Access Compliance Report

Public Rights-of-Way

(Curb Ramps)

Intersection ID: 9391	Main Street: FRANKLIN_AV	Cross Street: OLANDO_ST	Location: NW
ADA ID: A378B4FF39C4	Ramp Type: Para	Initial Pass/Fail: Fail	Overall Compliance: No
Codes/Mitigation Info/Possible Solution		Field Measurements/Component Compliance	
Severity Score: 13.75

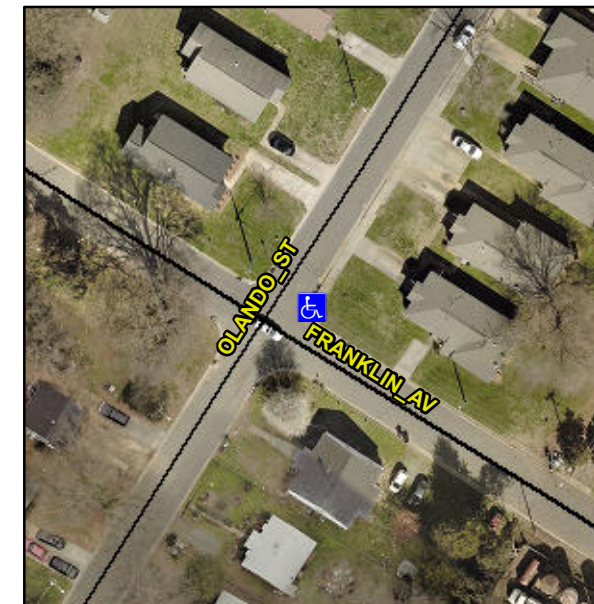
CURB GAP 1.5, LT RP < 5%

R304.5.3, R304.3.2

Remove & Replace Entire Ramp.
